Engagement Summary Report

Regulation Redesign

Amendments to Simplify Height Regulations

May 2021

Illustration of height measurement

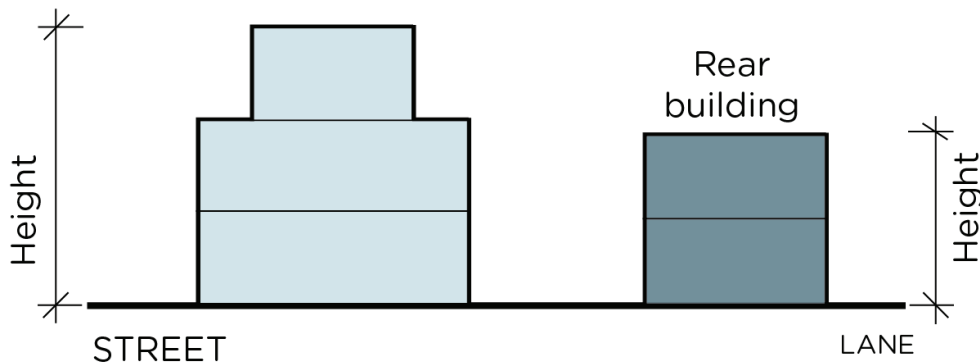
How is the base surface measured? How are steep sites considered vs flat ones? Is the height measured on existing or finished grades? Do the existing grades function well for drainage in the first place? Are the heights measured from the property line, or from some virtual surface? There are currently far too many ways of calculating grade, and this needs to be better established.

You need to clarify/specify what part of the building height is measured to: i.e. top of parapet, top of mechanical equipment screen, top of architectural armature, top of slab, top of mechanical equipment itself, top of spire. Occasionally rezoning height is written in the body of the report as to top of slab. For towers, it would be helpful to incentivize tops of buildings that look resolved and integrated as opposed to the dog house mechanical penthouses that appear as add-ons because they're excluded from height if they conform to certain dimensions.

I would prefer calculating from the highest point on the base surface. It is not clear what is being interpolated over in the definition. This seems to be a definition for someone who already knows what base surface means, as that is presumably what is interpolated? I think this is supposed to mean "the height of a building is measured from the highest point or points on a building to the base surface directly below that(/those) point(s)," but it does not come out and say that so I'm not sure.

Please consider removing the use of an "interpolated point directly beneath the highest point". Interpolation makes the process unnecessarily cumbersome for the sake of a few exceptional cases. Please consider a far simpler method as mentioned in your backgrounder PDF table that simply uses the average of the 4 finished building corner elevations.

Its unfair to use the old trope of interpolating existing grades as this makes sloped sites shorter than flat sites. Just pick the high point please or give an FSR based zoning envelope rather than making the entire building massing dependent on a single artificially dependent moment. Ie if there is a developed, zero side yard lot line on a sloped site it means an artificial halfway point will determine the overall height at the street? Or maybe height should be just based on visual massing from the street side property line or something - after all its the feeling of a building with relation to the street that is important not the math.

Sentences should flow more smoothly to facilitate quick reading. Instead of breaking up a key sentence to describe the definition of height, identify at outset that the heights of buildings must agree with requirements specified in district schedule.

Deal with sloping sites in the diagrams. This is particularly important on severely sloping sites.

Specify in more detail what the height definition would be if the property and building on it is on a sloped ground. (ie. Hills, Off a side of the Mountain, Above a Cliff, etc)

It's not clear what the definition of "vertical distance" is. Suggest that you combine the two sentences. "... be measured as the vertical distance between a point on the base surface directly beneath the highest point of the building"

Illustration of base surface

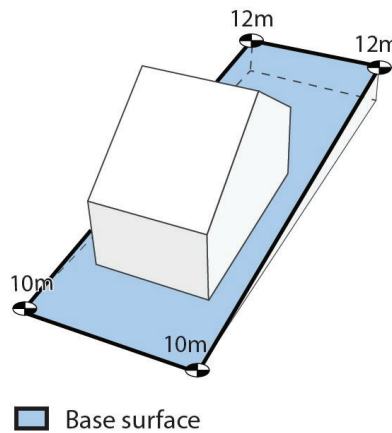
Fine - and please make the building grade process from the City engineers faster! Thanks.
I believe the province should revoke Vancouver's municipal land use power to regulate heights below 8 storeys. The new definition is fine, but irrelevant.
This definition works, but the height of the building should be taken from the lowest point of the base surface.
Good to have an image for illustration.
Sounds okay. A diagram with 4 different corner elevations would be more helpful.
Clear and a lot more defined, however it needs to be simplified better in terms of wording. Can something stated be said with more simpler words for the majority to understand? (I.e. A Drafting Student in a High School setting)
Fine with this definition
Fine
Clear.
Very clear.
Seems clear
again, seems reasonable
Again I oppose this.
What about a convex or concave site? There are plenty of sites on an escarpment for which averaging of 4 corners does not well depict what happens in the middle? Who determines this 'incompatibility'? Is it something that requires judgement and so presents uncertainty as part of a design process?

-the regulation should limit the decorative roof to a proportion of the height of the building to the base of the proposed decorative roof
Illustration is reasonably clear, but what do you mean by 'joining'? Explain the difference between 'official established' and 'existing grades'. It might help to have a definition that is NOT by-law language in addition to your by-law. You need an interpretive writer or technical writer on the team
Given that it is acceptable that a Base Surface may be inclined, does that mean that the building will also be allowed to have a roof that is also inclined, and parallel to the Base Surface, as no point on the rooftop would be further from the Base Surface than the highest point would be from the Base Surface?
the illustration shows elevations at 12 m at the north side of the property and 10 m at the south. Often times the north side will have different elevations as would the south side. For example 12m and 11.8 m on the corners at the north and 10 and 9.8 m on the south. The base surface is a warped plane. Then under the definition of height it's not clear how to interpolate.

Create sentences that are shorter, contain only one fact or piece of information. This speeds up reading and helps understanding.
Interpolation means official surveyed measure of height.
Generally 4 points don't make a plane. You should define which interpolated grade you calculate first. side to side then front to back?
For single family and similar projects, please reconsider and just use the average of the 4 finished building corner elevations. It's a much simpler approach.
